# SERVICE ADVISORY

NO.: 0837

**TO:** All Garmin Aviation Service Centers  
**DATE:** October 27, 2008  
**SUBJECT:** G600 NAV/ILS Glideslope Display and GPS signal

**LOC/ILS is the selected navigation source**

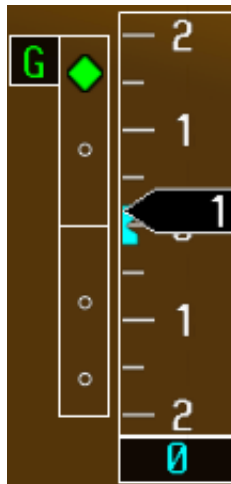
In GDU 620 version 2.01 software, ILS glideslope information will only be displayed if the GDU 620 has valid GPS position information. On the PFD, glideslope information is displayed immediately to the left of the VSI indicator, as shown below. The display of localizer information is not affected.

A future software version will address this issue where the GDU 620 will not require valid GPS position in order to display ILS glideslope information.
